BID ADDENDUM NO. 2

November 12th, 2026
Corning-Painted Post ASD
2025 Erwin Valley Elem & Admin Building Alterations
2649-160

The following Addendum items shall be considered a part of the contract documents prepared by HUNT ENGINEERS, ARCHITECTS, LAND SURVEYORS & LANDSCAPE ARCHITECT, DPC. Bid Document date of October 12, 2026

AD2-L1

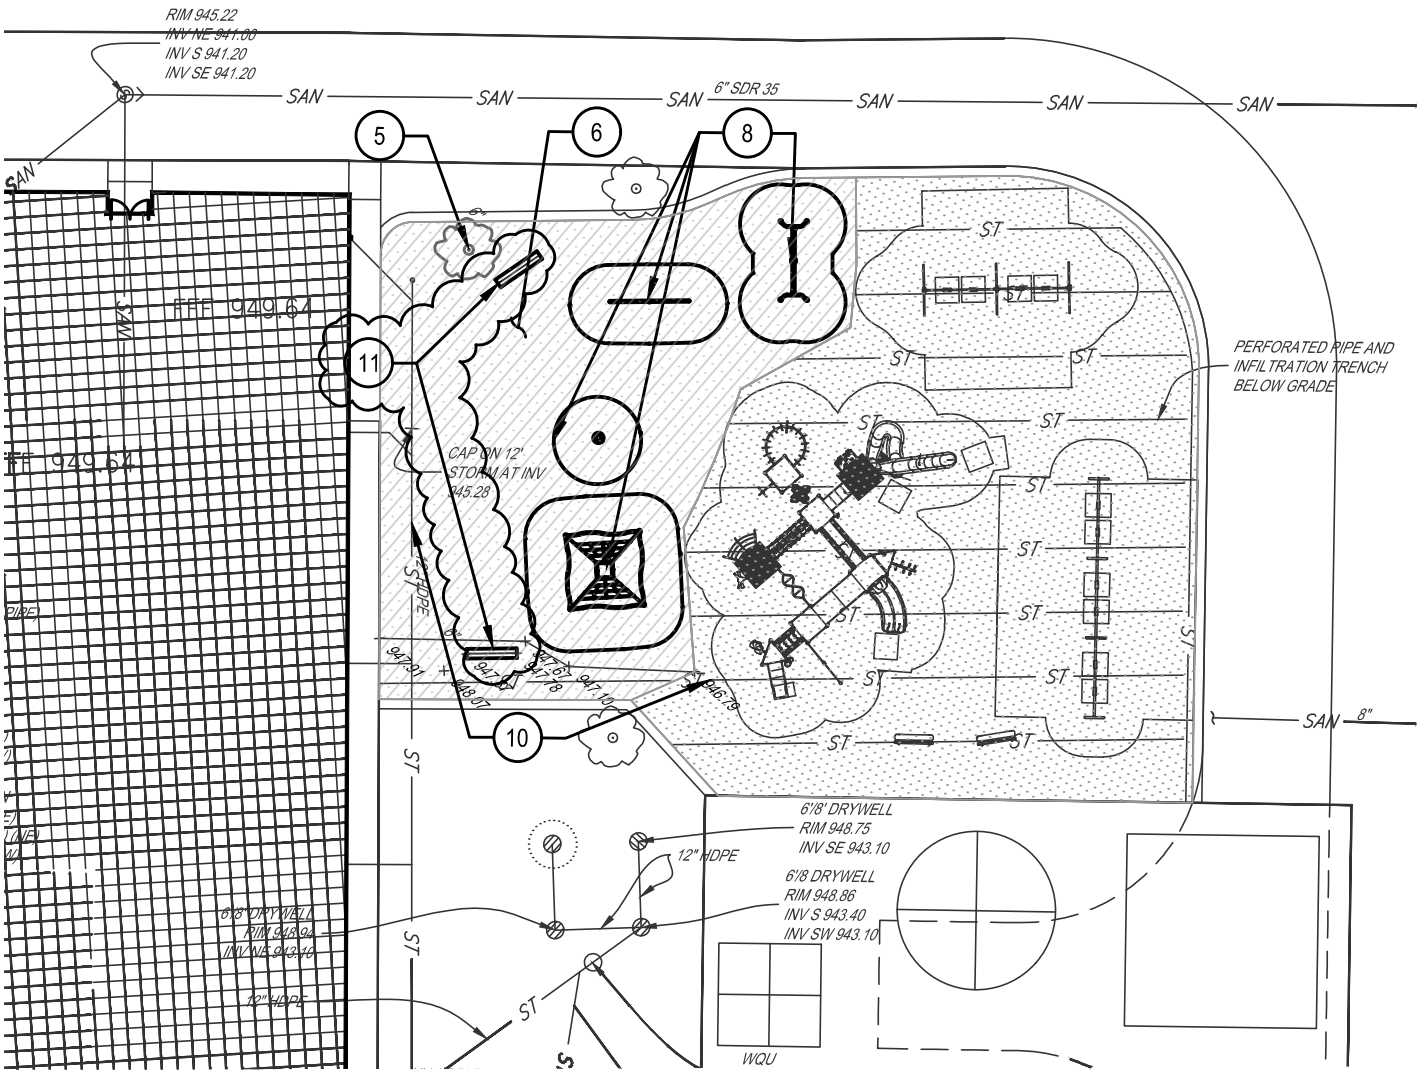
ITEM AD2-20 Refer to Drawing EV-L1.1 SITE DEMOLITION PLAN
ADD Drawing AD2-L1 – REVISED DEMOLITION PLAN - PLAYGROUND, as issued in this addendum.

8. ALTERNATE 2: REMOVE EXISTING PLAYGROUND EQUIPMENT AND FOUNDATIONS.
9. IF NECESSARY FOR NEW UTILITIES, TEMPORARY REMOVE FENCE AND GATE AND REINSTALL IN THE SAME LOCATION AFTER PROJECT COMPLETION.
10. PROTECT EXISTING UTILITY LINE AND STRUCTURES TO REMAIN.
11. REMOVE EXISTING BENCHES AND FOUNDATIONS.

1 AD - FIRST FLOOR PLAN - AREA B KITCHEN - REF. 2/EV-A1.2

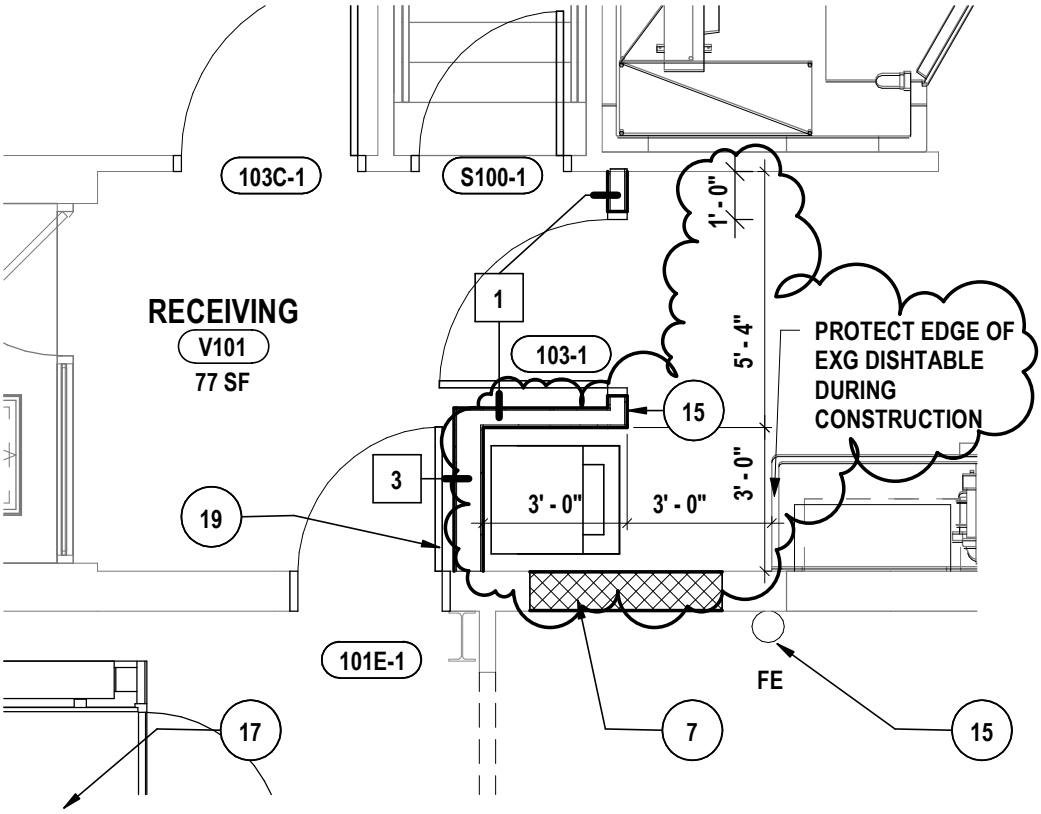
ITEM AD2-31 Refer to Drawing EV-A1.2 FIRST FLOOR PLAN - AREA B
AMEND View #2 as clouded on Sheet AD2-A1 issued with this addendum.

1 AD - FIRST FLOOR DEMOLITION PLAN - AREA A LIBRARY - REF. 1/EV-A0.1

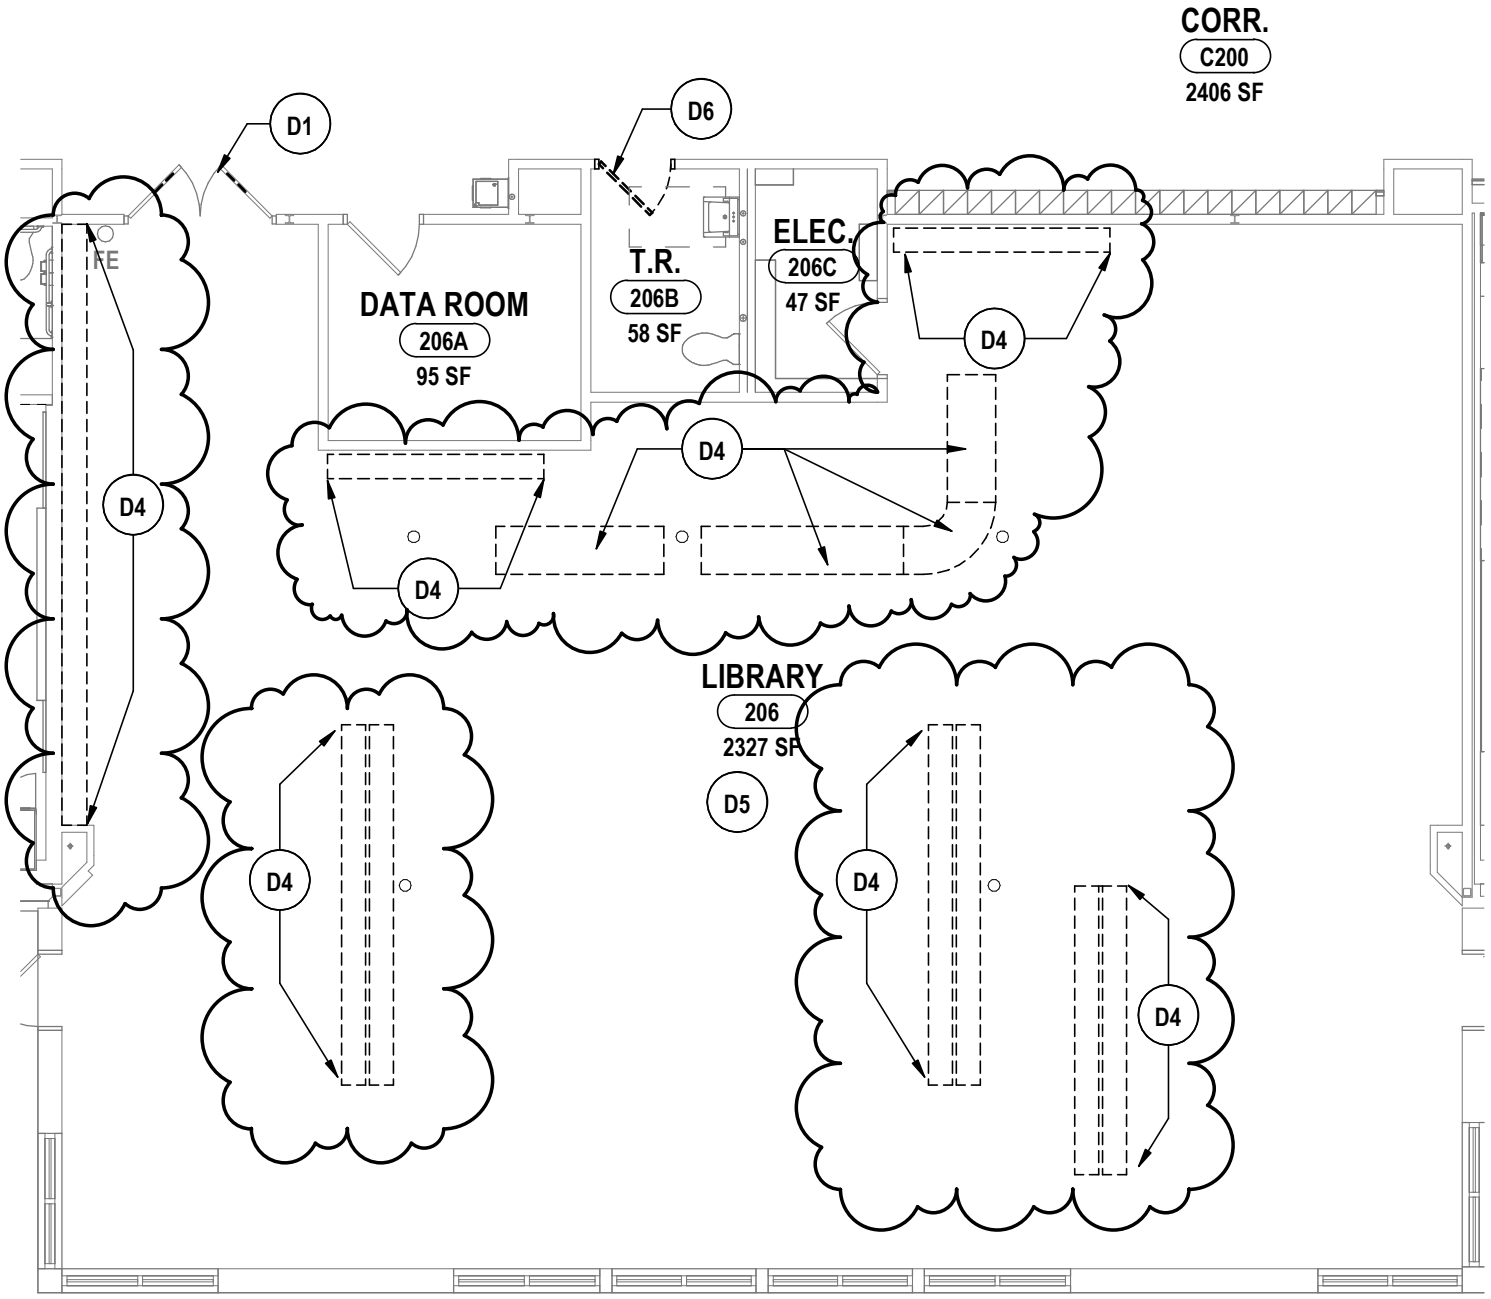
ITEM AD2-28 Refer to Drawing EV-A0.1 FIRST FLOOR DEMOLITION PLAN - AREA A
AMEND View #1 as clouded on Sheet AD2-A2 issued with this addendum.

1 AD - FIRST FLOOR PLAN - AREA A - REF. 1/EV-A1.1

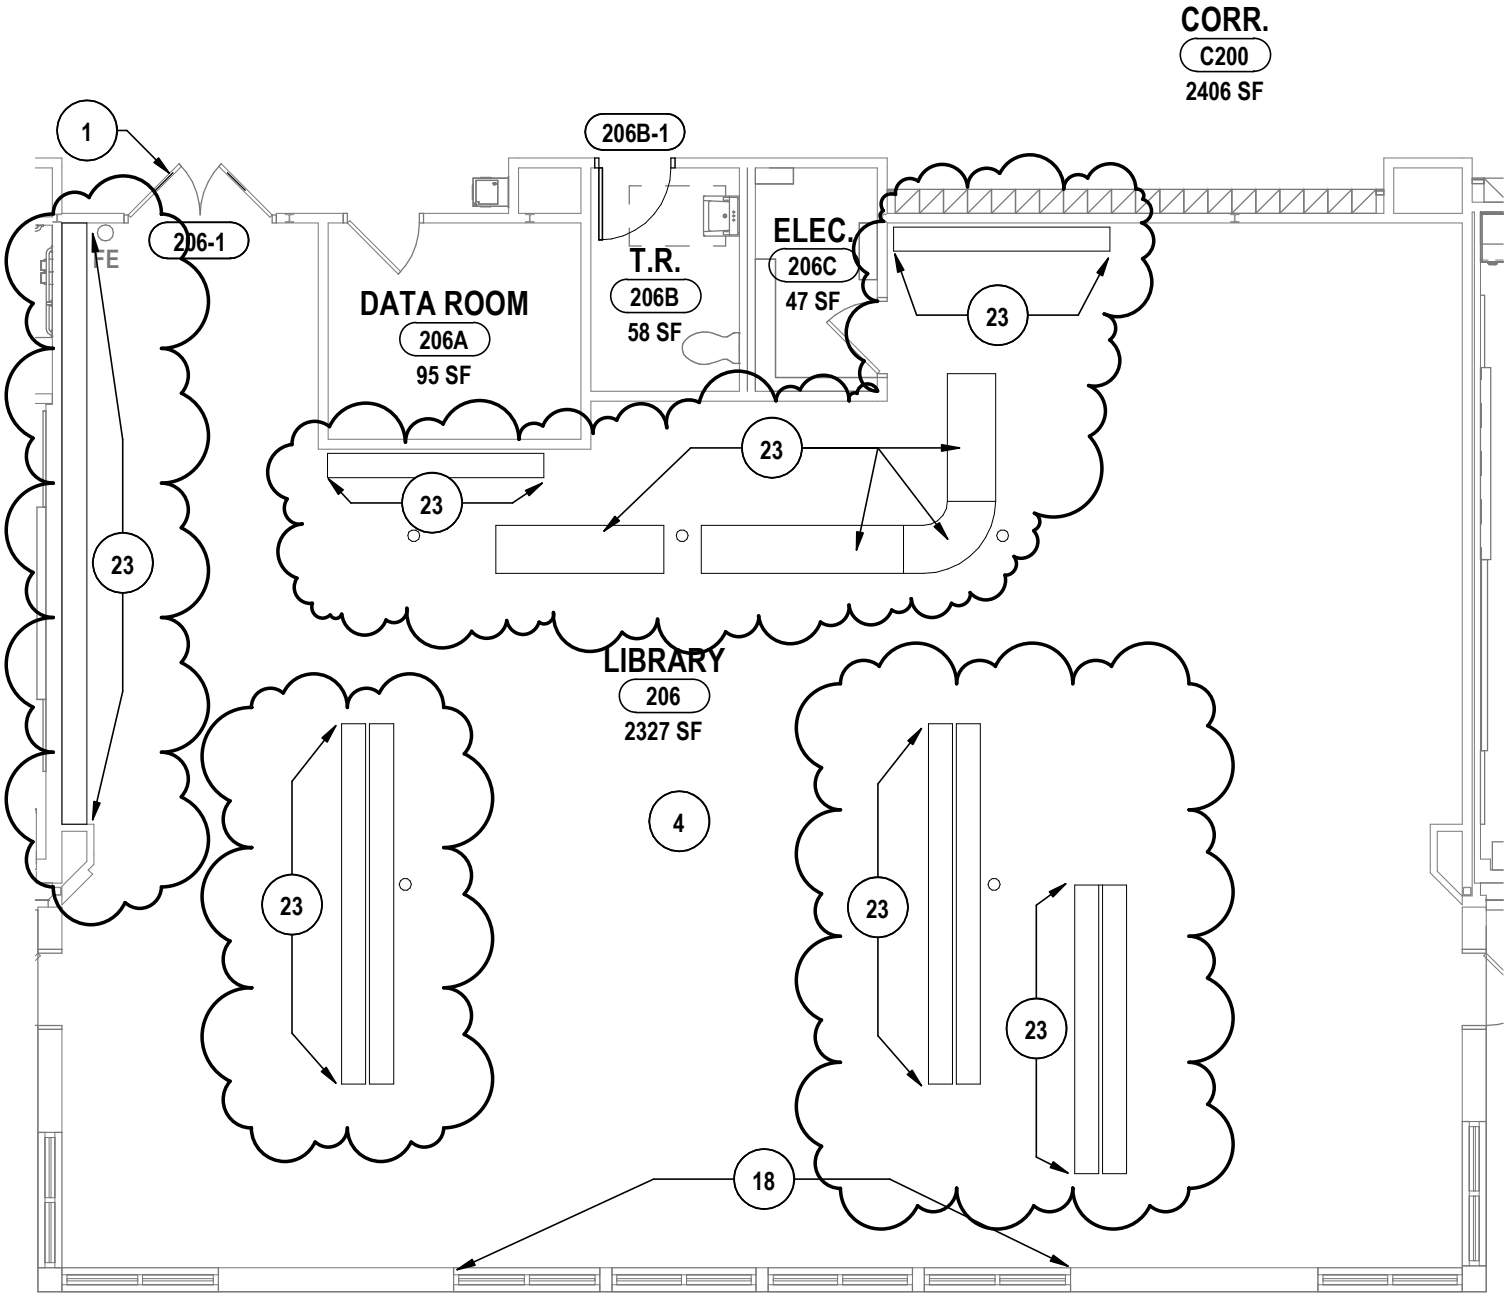
ITEM AD2-30 Refer to Drawing EV-A1.1 FIRST FLOOR PLAN - AREA A
AMEND View #1 as clouded on Sheet AD2-A3 issued with this addendum.

1 UNISTRUT, CURTAIN & TRACK PLAN

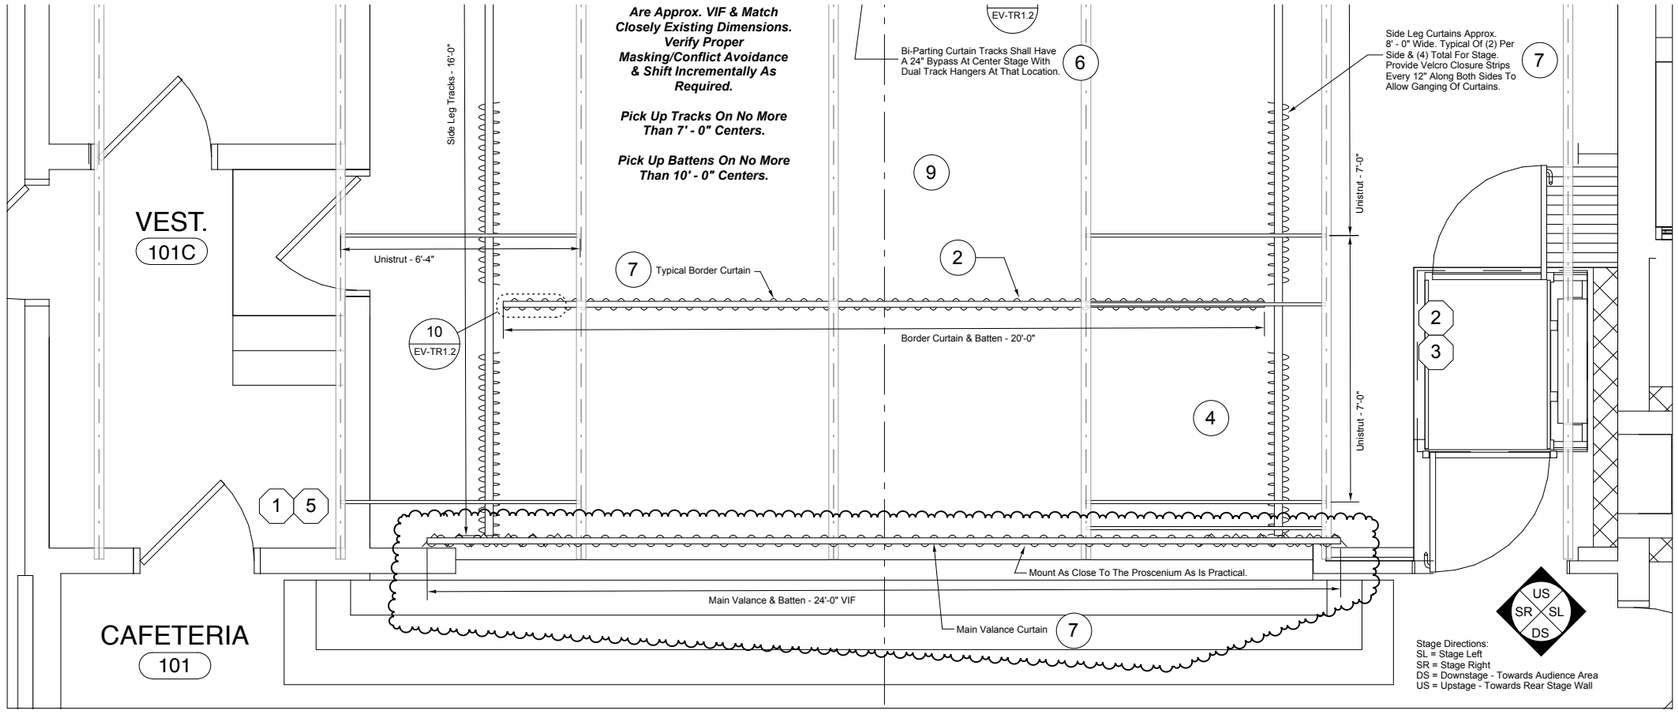
ITEM AD2-55 Refer to Drawing EV-TR1.1 - THEATRICAL RIGGING PLAN, SECTION & ELEVATION - AREA B
AMEND View #1 as clouded on Sheet AD2-TR1 issued with this addendum.

1 REVISED TOILET ROOM SANITARY PLAN - AREA D

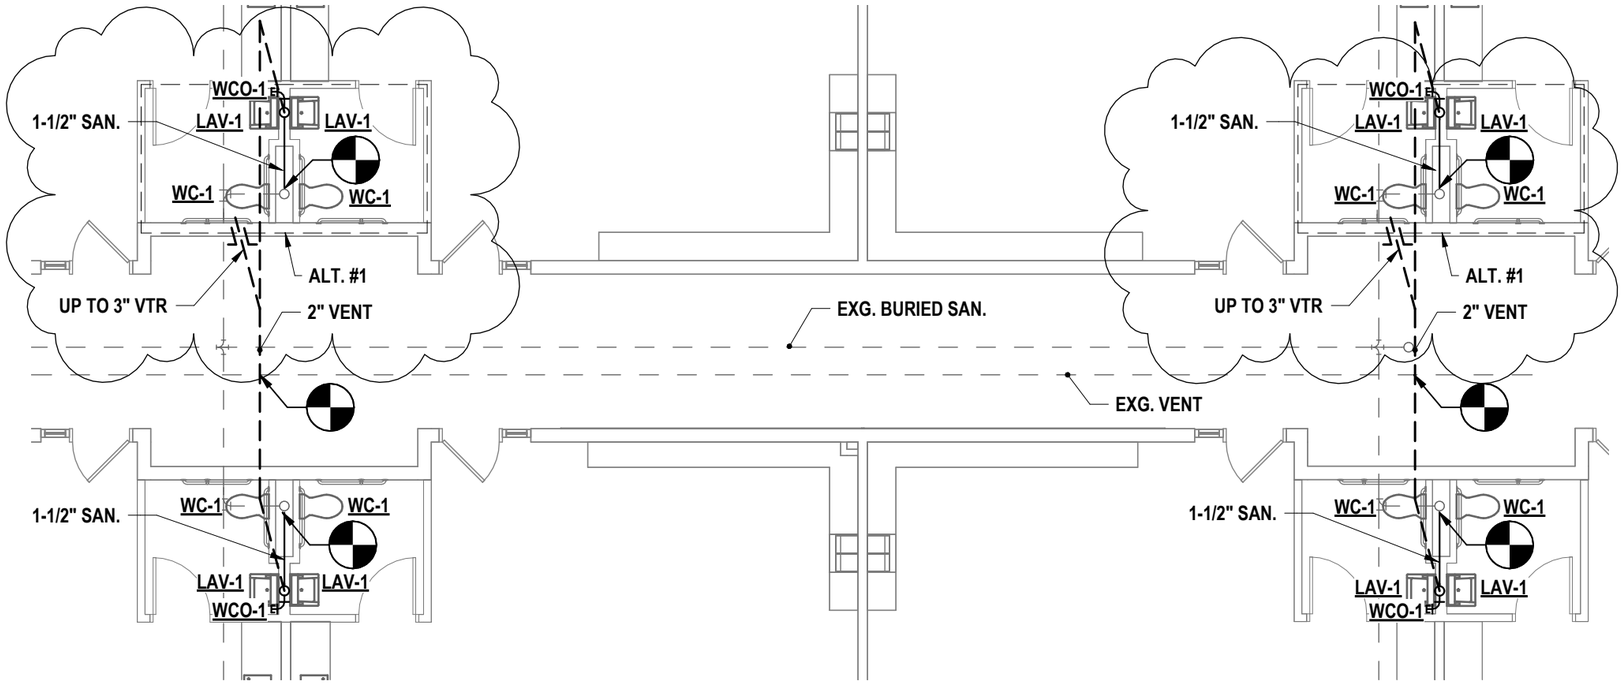
ITEM AD2-58 Refer to Drawing EV-P1.1 - FIRST FLOOR PLANS - AREA D
AMEND Detail 1 with AD2-P1 - REVISED TOILET ROOM SANITARY PLAN - AREA D, as issued in this addendum.

1 FIRST FLOOR LIGHTING & FA PLAN - BATHROOM PLAN

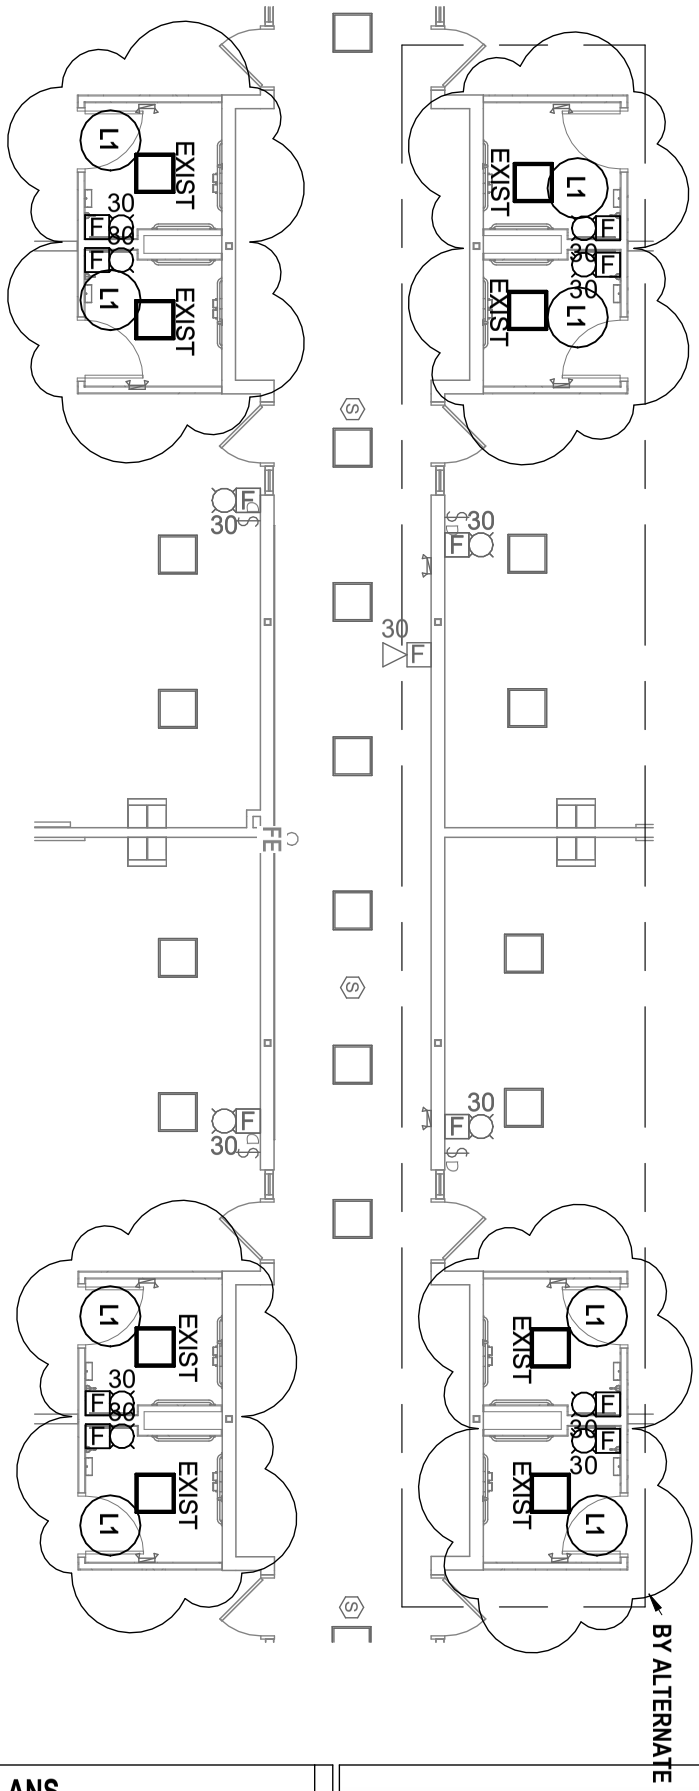
ITEM AD2-64 Refer to Drawing EV-E2.2 - FIRST FLOOR LIGHTING & FA PLAN - AREA D
AMEND Detail 1 with AD2-E1 - REVISE FIRST FLOOR BATHROOM PLANS, as issued in this addendum.

1 FIRST FLOOR LIGHTING & FA PLAN - KITCHEN PLAN

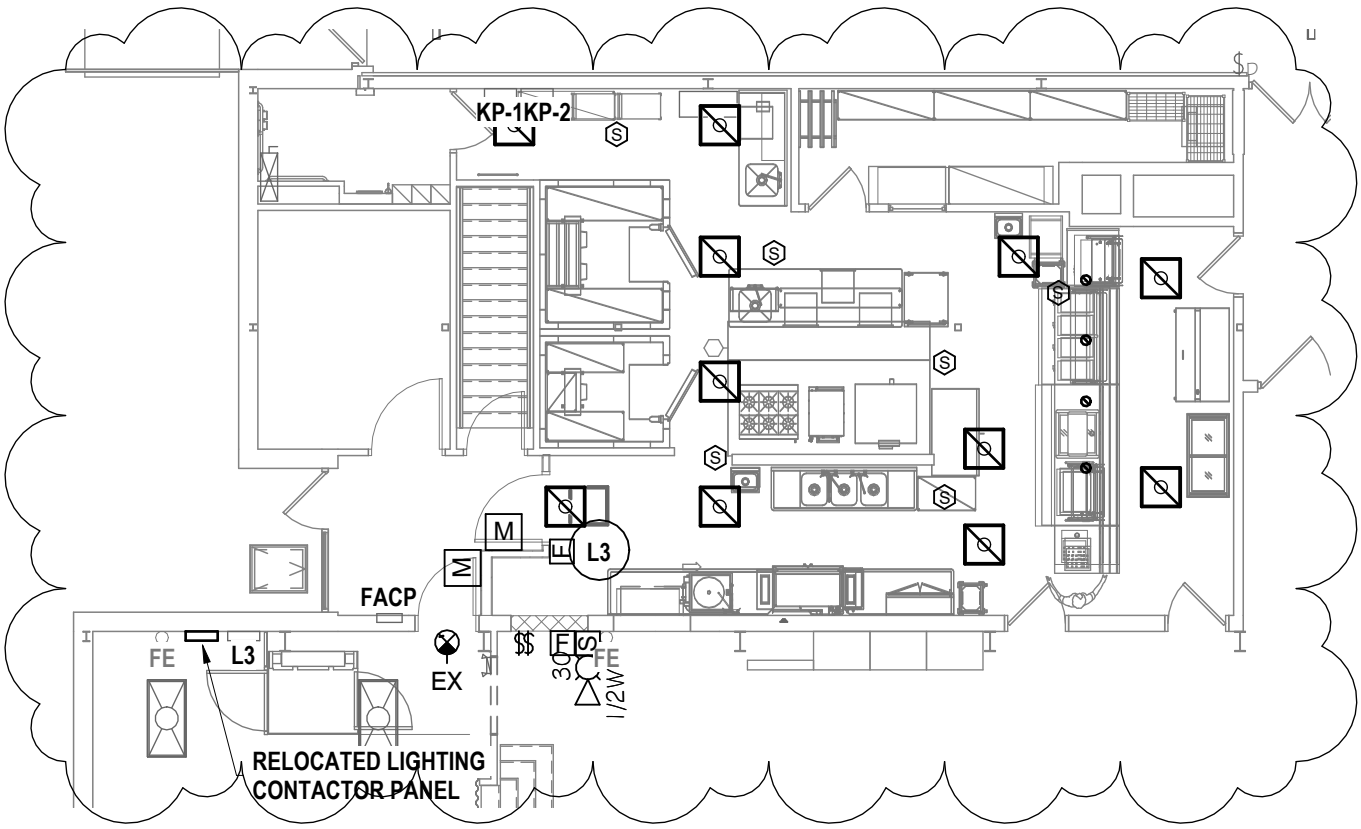
ITEM AD2-63 Refer to Drawing EV-E2.1 - FIRST FLOOR LIGHTING & FA PLAN - AREA B
AMEND Detail 1 with AD2-E2 - REVISED KITCHEN PLAN, as issued in this addendum.
